# Access Compliance Report

## Public Rights-of-Way

### (Curb Ramps)

| Intersection ID: 23437 | Main Street: MOSS_RD | Cross Street: S_TRYON_ST | Location: NW           |

| ADA ID: E1BA3400E234   | Ramp Type: Perp      | Initial Pass/Fail: Fail  | Overall Compliance: No |

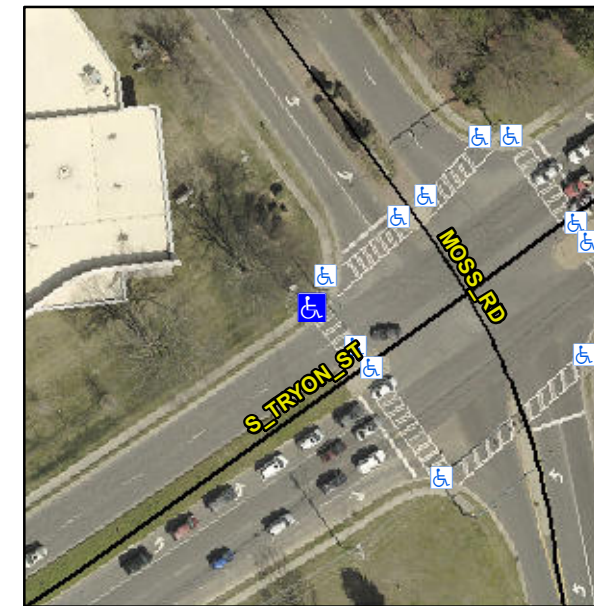
**R304.5.1, R304.5.3**

| Compliance | Description           | Data  | Compliance | Description                 | Data |
|------------|-----------------------|-------|------------|-----------------------------|------|
| No         | Ramp Width (in)       | 46.0  | No         | Ramp XSlope (%)             | 2.2  |

**Remove & Replace Entire Ramp.**
